KITTERY TOWN PLANNING BOARD MEETING

AGENDA for Thursday, April 9, 2015

ITEM 1 – Bartlett Hill Multifamily Cluster Subdivision – Subdivision Preliminary Plan Review

**RE: Town of Kittery, Planning Board Services
Bartlett Hill Subdivision Preliminary Review #3
Route 236 and Fernald Road, Tax Map 28, Lot 14
CMA #591.75**

CIVIL CONSULTANTS	
DRAWN JAA	CALC. JES
DATE 12 SEPTEMBER 2013	
CHECKED	
APPROVED	
SCALE AS NOTED	
SHEET TITLE: SECTIONS	
SHEET NUMBER: C7	
SHEET 7 of 7	
PROJECT # 12-198.00

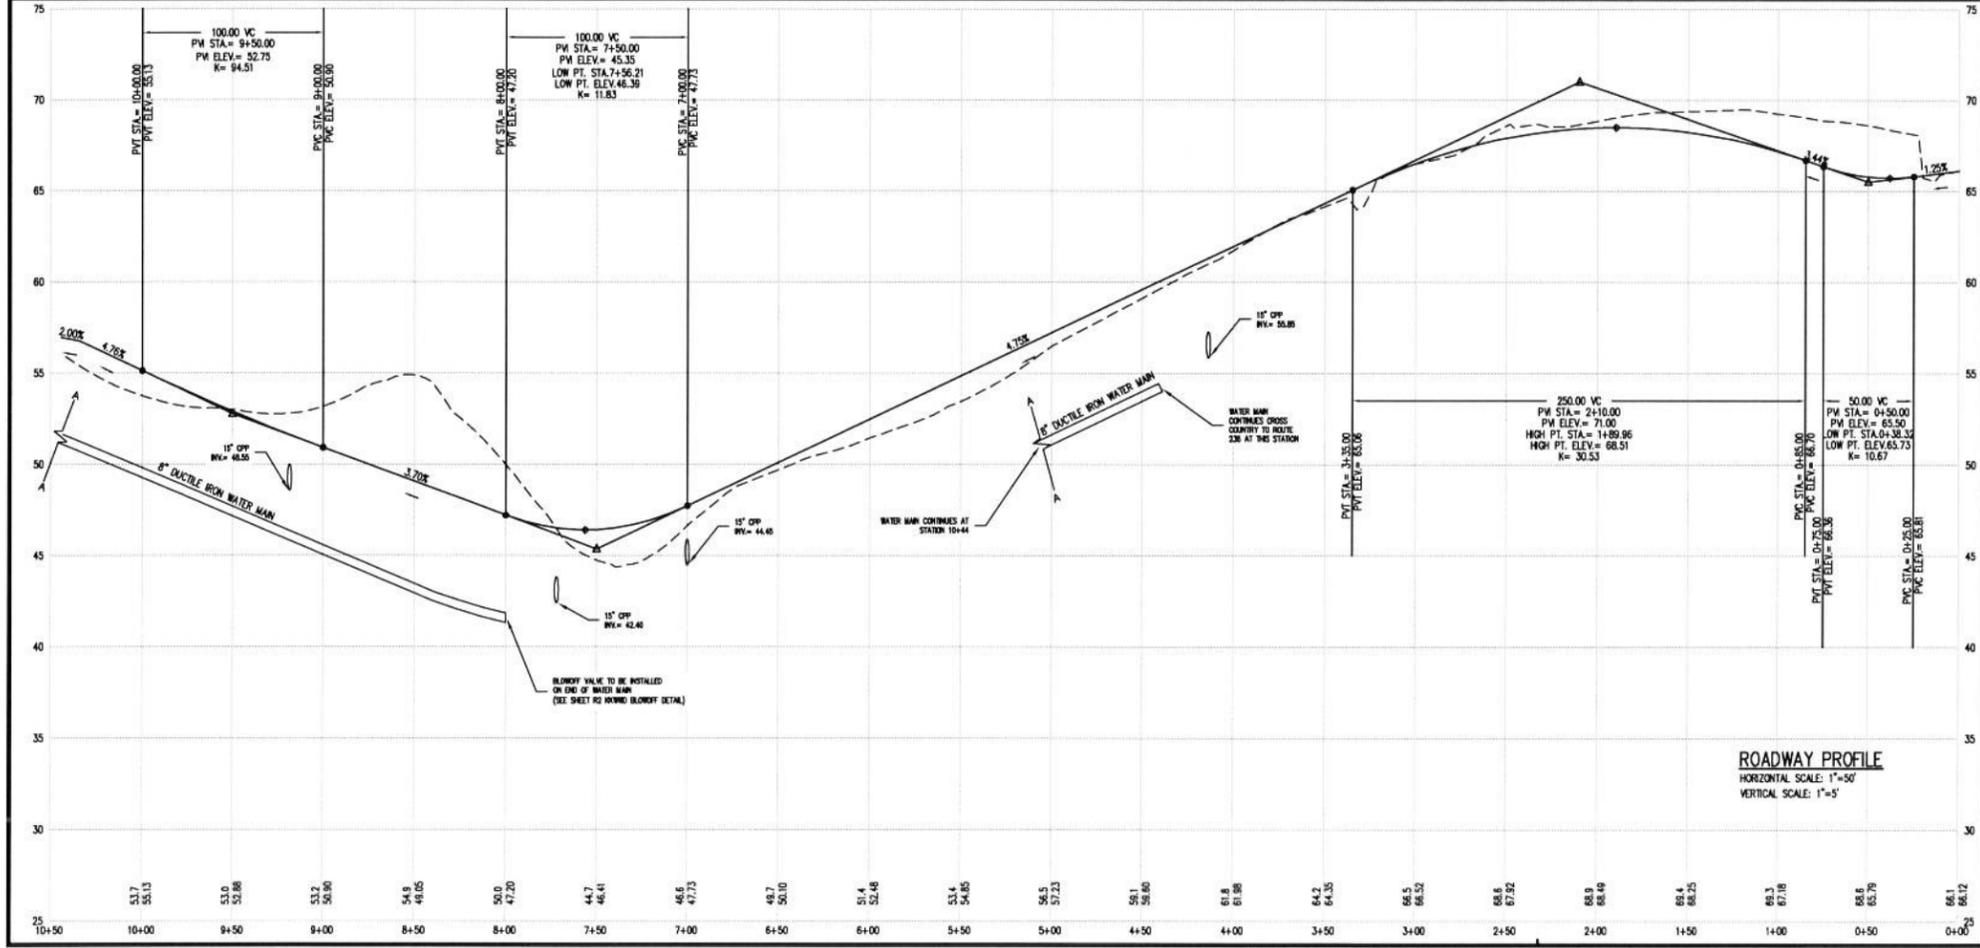
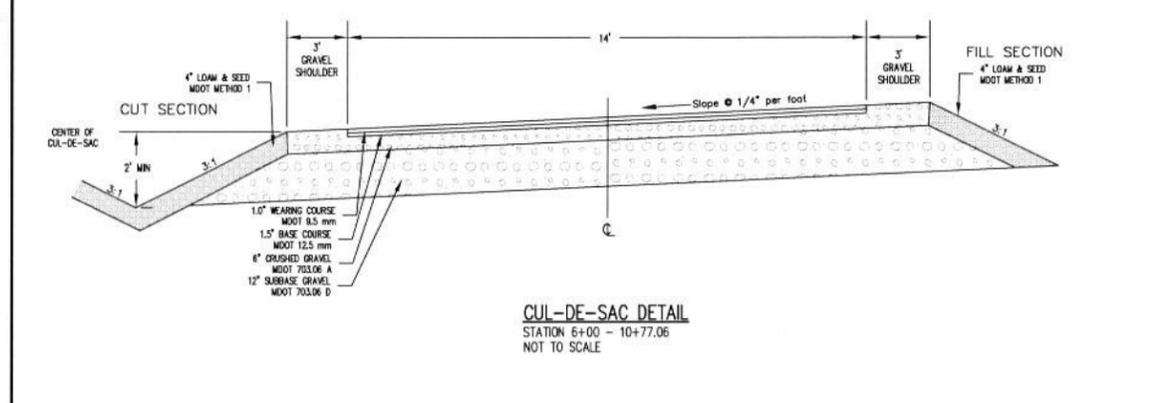
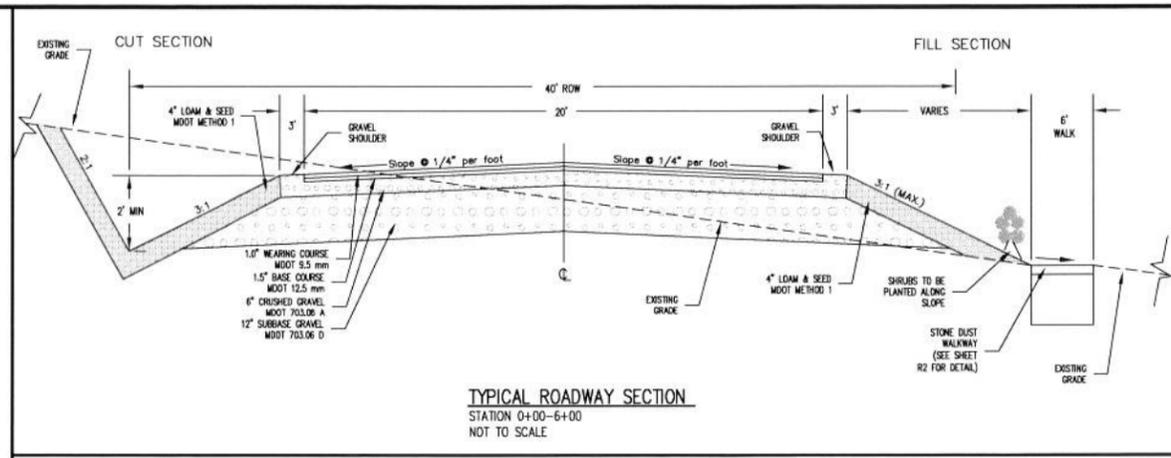
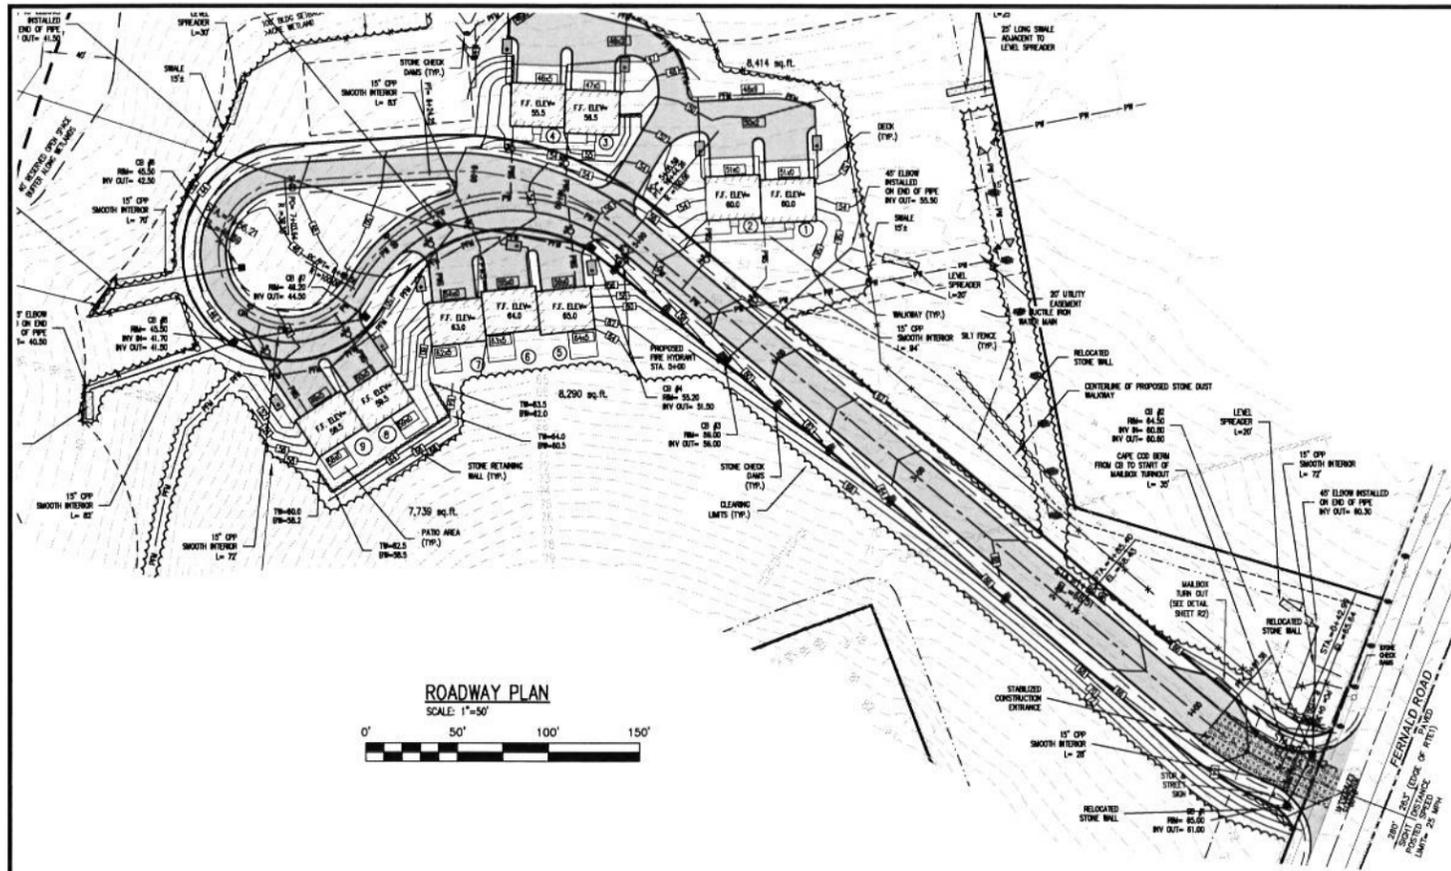
1. Units 8 and 9 show a retaining wall system with a 2:1 backslope (Section D-D on Sheet C7). Final subdivision review should include structural and geotechnical feasibility of this design.

PAVED WALKWAY DETAIL
NOT TO SCALE

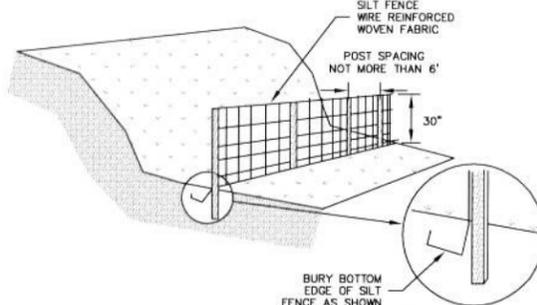
Sidewalk/Pedestrian Way: The Typical Roadway Section detail on Sheet R1 includes a 6-ft walk. The walk location and extents are not indicated on the plan or reflected on the grading plan.
